BEFORE THE CHRISTCHURCH CITY COUNCIL

IN THE MATTER of an application by Ryman Healthcare Limited for resource consent to establish and operate a comprehensive care retirement village at 100-104 Park Terrace and 20 Dorset Street, and 78 Park Terrace, Christchurch

**STATEMENT OF EVIDENCE OF ANTONI FACEY ON BEHALF OF CENTRO
ROYDVALE LIMITED**

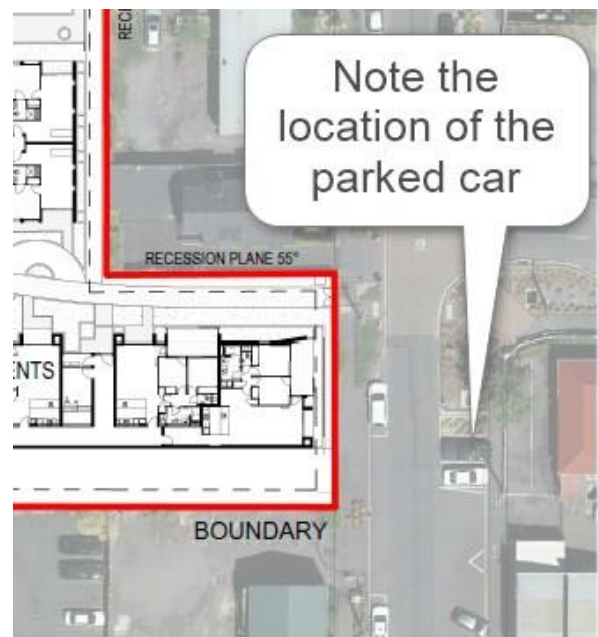
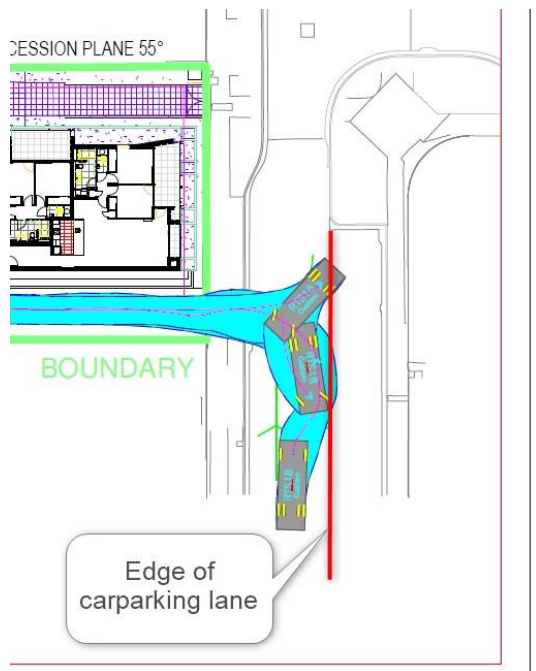
- 18 The Applicant's tracking curves shown for a truck reversing from the site are shown below. I have added a red line where vehicles can be parked on the northern side of Dorset Street. An example of a vehicle parked in the area can be seen in the aerial photo below so it is clear that vehicles can be parked in this location.

- 19 The Applicant's tacking curves show that an 8 m truck reversing from the site cannot do so without encroaching on the carparking space by a considerable distance. If a car is parked in the space, the applicant must show how a truck will exit the site. This may require the truck to exit the site towards Park Terrace. In that case, the truck is expected to reverse onto the wrong side of the road to perform the turn.
- 20 A similar assessment should be carried out for the larger trucks that are expected to use the Site.

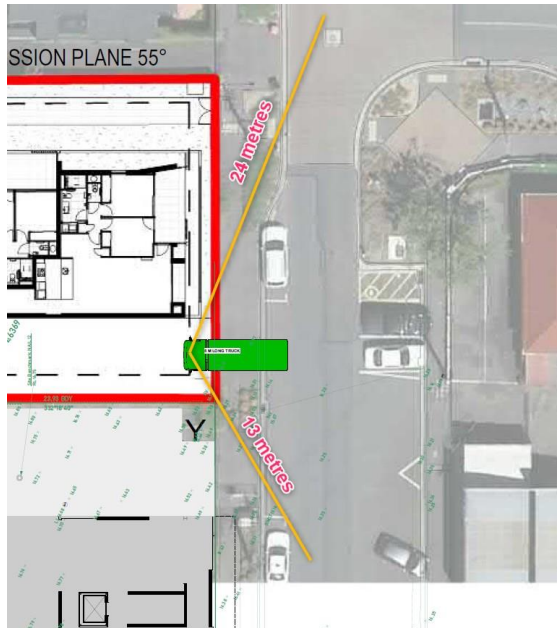
- 24 The drawing below shows an 8 m truck reversing from the site. The truck has been located on the line of the parked vehicle and the kerb extension. This is approximately 2 metres into the carriageway. Although undesirable, the truck should not be blocking the carriageway since the kerb extension in particular will prevent drivers on Dorset Street from driving closer to the kerb than this. As can be seen from the drawings below, the driver's location in the truck is still about 2 metres within the Site. The sight distance could then be reduced to 24 metres or less depending on conditions on the boundary. This is insufficient for a driver to safely exit the site.

- 25 Sight distance to the east is potentially only 13 metres due to the Orion kiosk on the boundary reducing sight distance. The cab of the truck itself will also create a larger blind spot adjacent to the truck where the mirror will not be effective.

- 26 A 12 m truck has also been shown in the same position. The sight distance is reduced even further.
